Access Compliance Report

Public Rights-of-Way

(Curb Ramps)

Intersection ID: 15139	Main Street: EAST_BV	Cross Street: KENILWORTH_AV	Location: W
ADA ID: D6C9FA93EE68	Ramp Type: PerpDiag	Initial Pass/Fail: Fail	Overall Compliance: No
Severity Score: 10			
Codes/Mitigation Info/Possible Solution		Field Measurements/Component Compliance

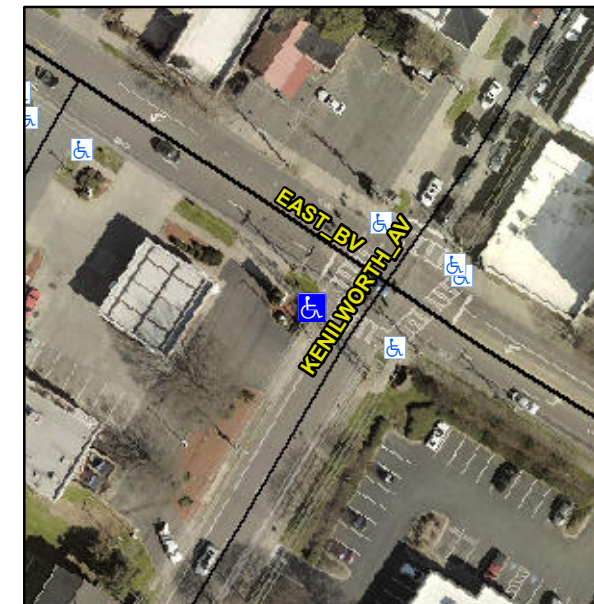
Not Found, R304.5.1

Compliance	Description	Data	Compliance	Description	Data
N/A	Ramp Length (in)	69.5	Yes	Ramp Slope (%)	6.5
No	Ramp Width (in)	43.0	Yes	Ramp XSlope (%)	3.4
N/A	Flare Type LT	N/A	N/A	Flare Type RT	N/A
N/A	Flare Slope LT (%)	N/A	N/A	Flare Slope RT (%)	N/A
N/A	Flare Traversable LT?	N/A	N/A	Flare Traversable RT?	N/A
N/A	Landing Length (in)	N/A	N/A	DWS Provided?	N/A
N/A	Landing Width (in)	N/A	N/A	DWS Contrast?	N/A
N/A	Landing Slope (%)	N/A	N/A	DWS Length (in)	N/A
N/A	Landing X Slope (%)	N/A	N/A	DWS Full Width?	N/A
N/A	Landing Curb? (Y/N)	N/A	N/A	DWS Offset (in)	N/A
N/A	Shared Landing?	N/A			
N/A	Gutter Ponding?	N/A	N/A	Gutter Slope (%)	N/A
N/A	Gutter Lip Ht (in)	N/A	N/A	Gutter X Slope (%)	N/A
N/A	Painted X Walk1?	Yes	N/A	Painted X Walk2?	Yes
	X Walk 1 Direction	To SE		X Walk 2 Direction	To NE
N/A	X Walk 1 Width (in)	110.0	N/A	X Walk 2 Width (in)	110.0
	X Walk 1 Slope (%)	0.7		X Walk 2 Slope (%)	7.0
	X Walk 1 X Slope (%)	4.3		X Walk 2 X Slope (%)	0.2

Remove & Replace Curb Ramp With Two New Directional Ramps or Equivalent.
